**Kit No. 76-4004-1 S**

**SUBJECT:** **WINGS - INSTALLATION OF WASHERS ON THE WING LOWER SPLICE PLATE BOLTS AND INSPECTION OF THE WING UPPER SPLICE PLATE**

DB-334 M

**Issued: August, 1985****Revised: July, 1987****1 of 4**

### UPPER SPLICE PLATE Figure 2

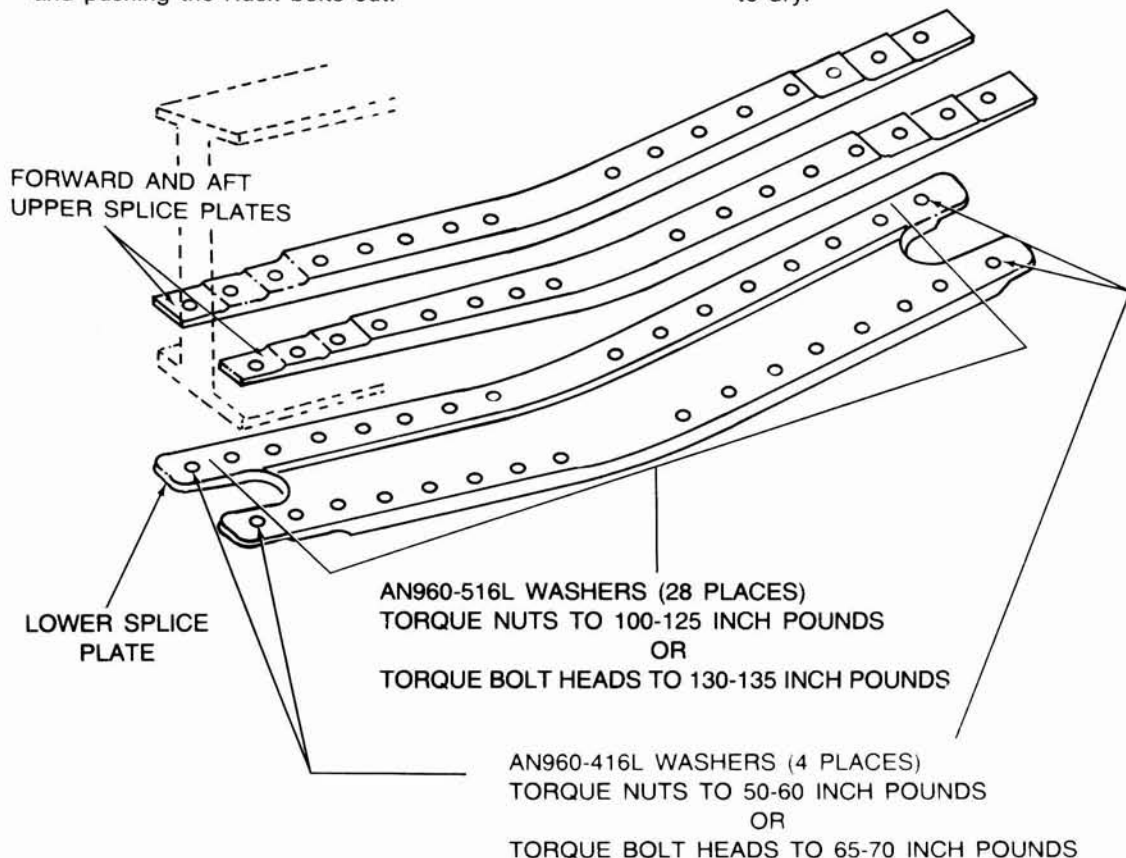
5. Inspect the wing upper splice adjacent to each of the six center forward Huck bolts for tool marks in the radius of the web and splice plate. See Figure 2.

6. If no tool marks are found, proceed to Step 14.
7. If tool marks are found, and are less than .050 inch deep, remove the affected Huck bolts in the upper splice plate by splitting the collars with a P/N 105-10 collar splitter or equivalent and pushing the Huck bolts out.

8. Polish the tool marks out evenly using aluminum oxide paper or cloth. Finish polish with 400 grit or finer aluminum oxide paper or cloth.
9. If the tool marks are deeper than .050 inch, contact:  
Beech Aircraft Corporation Commercial Service Department Wichita, Kansas Telephone (316) 681-8495 TWX No. 203603
10. Coat the areas which were polished in Step 8 with ALODINE 1200, 1200S or 1201 chemical conversion coating (obtain locally). Allow the coating to dwell (five minutes). Wash the coated areas with water and blow dry with air (do not wipe dry). Paint the treated areas with zinc chromate primer (obtain locally) and allow to dry.

11. Install a P/N 130909B98 bolt (head up), with a P/N MS20002C5 washer under each bolt head into the the upper splice plate. Ensure that the chamfered side of the washer is against the bolt head.
12. Install a P/N AN960-516 washer and a P/N MS20365-524A nut on the bolts which were installed in the previous step. A maximum of three P/N AN960-516 washers may be used under each nut.
13. Torque the nuts to 100-125 inch pounds or the bolt heads to 130-140 inch pounds.
14. Reinstall the spar cover, spar inspection plate and the floorboard assemblies.

**LOWER SPLICE PLATES**  
Figure 1

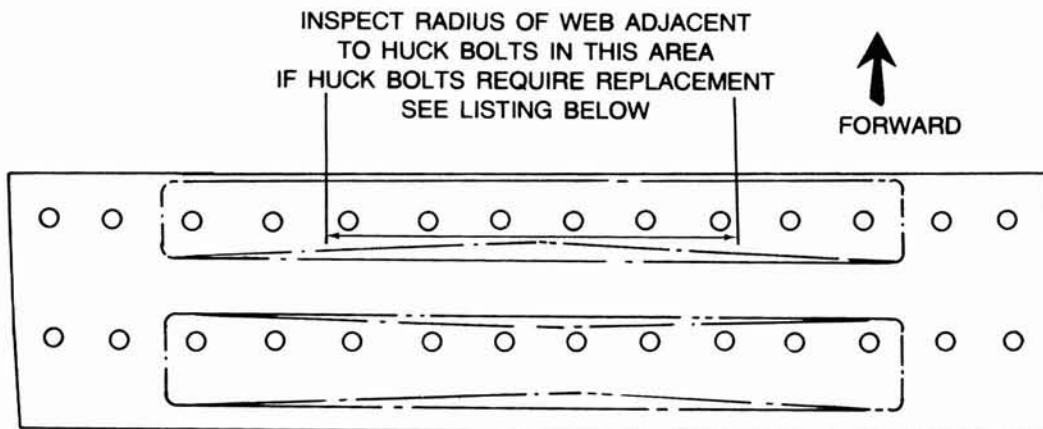
3. Install a P/N AN960-416L washer, in addition to the existing washer, under the nuts on the two bolts on each end of the lower splice plate. Torque the nuts to 50-60 inch pounds or torque the bolt head to 65-70 inch pounds.

4. Install a P/N AN960-516L washer, in addition to the existing washer, to each of the remaining twenty-eight bolts. Torque the nuts to 100-125 inch pounds or torque the bolt heads to 130-135 inch pounds. See Figure 1.

130909B98 BOLTS  
MS20002C5 WASHERS (UNDER BOLT HEAD)  
AN960-516 WASHERS (UNDER NUT-MAX. 3 EA. BOLT)  
MS20365-524A NUTS

TORQUE ON NUTS 100-125 INCH POUNDS  
TORQUE ON BOLT 130-135 INCH POUNDS
